**Pipeline Replacement FY23  
FPUD Job 3186**

**ADDENDUM B**

*August 10, 2022*

This Addendum "B" includes clarifications and/or changes to the Contract Documents for the Fallbrook Public Utility District, **Job 3186, Pipeline Replacement FY23.**

DRAWING NO.  
**W-5**

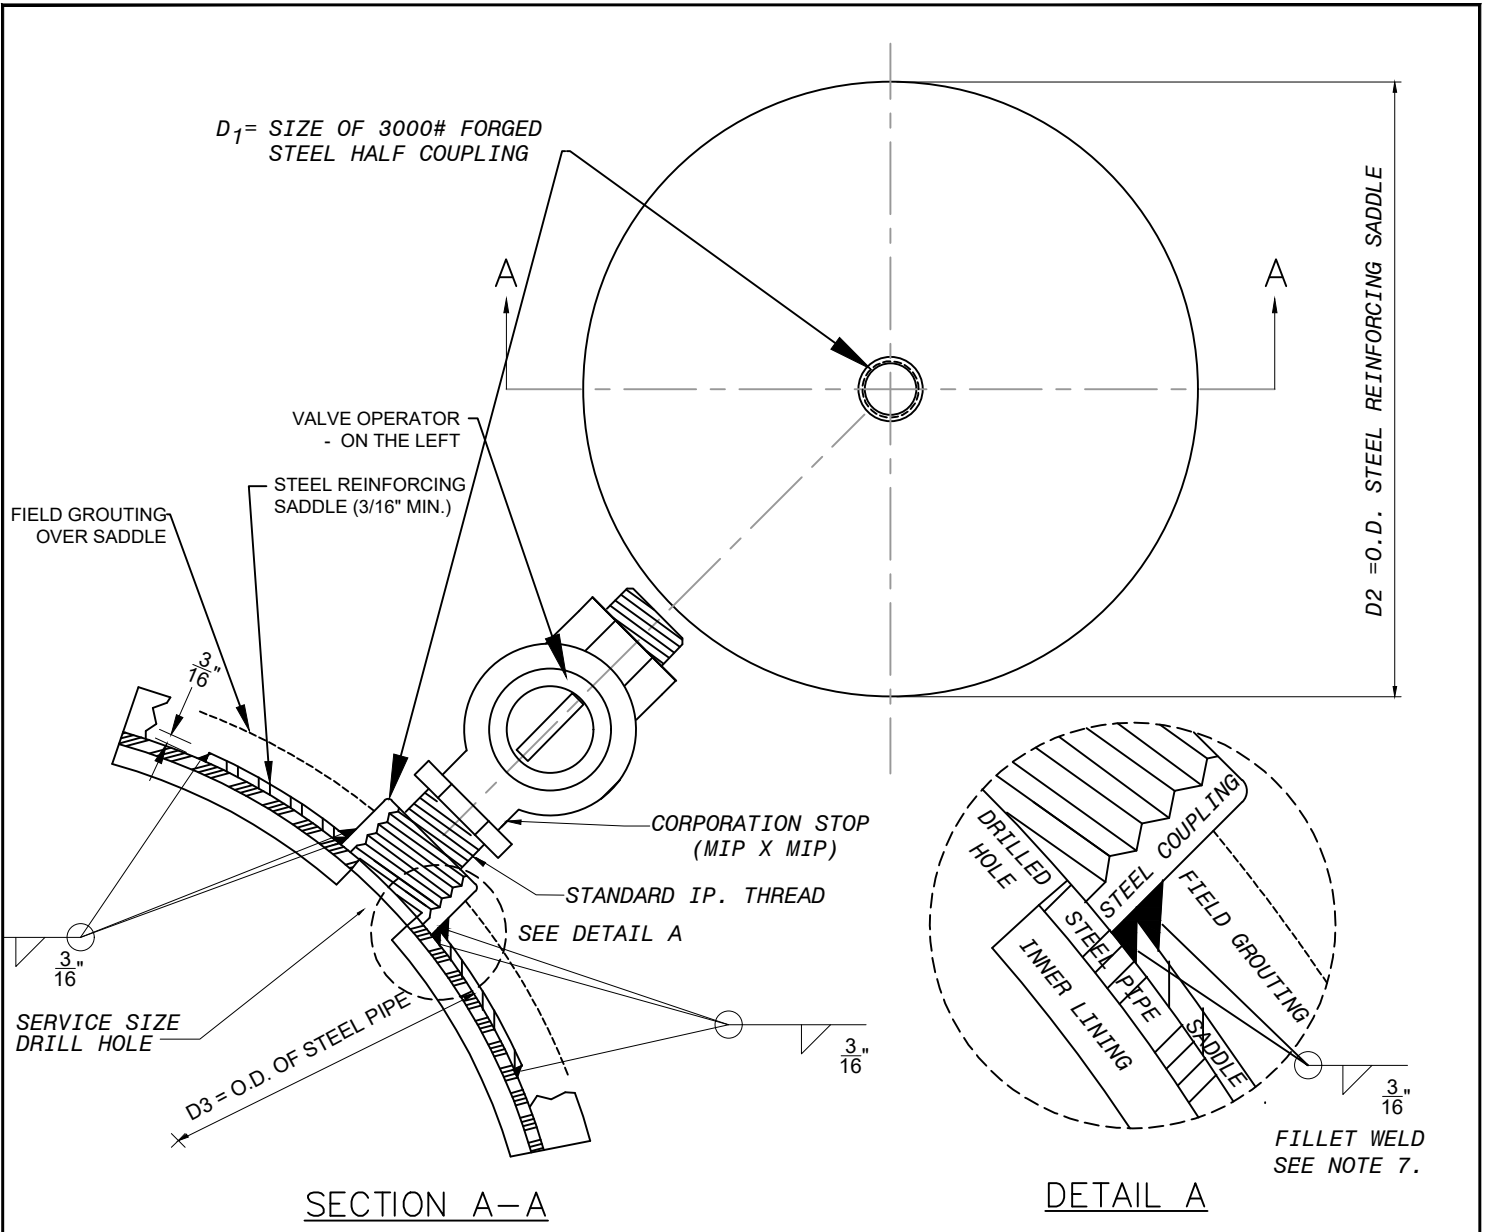
- All services are to have Service outlet per W-5. Per the saddle dimension drawing it has D-1 has the outlet size larger then the service. Do you require a nylon bushing but note 6 says no bushings allowed?

Response: See Revised W-5. Coupling to be same size as service line, 1" minimum.
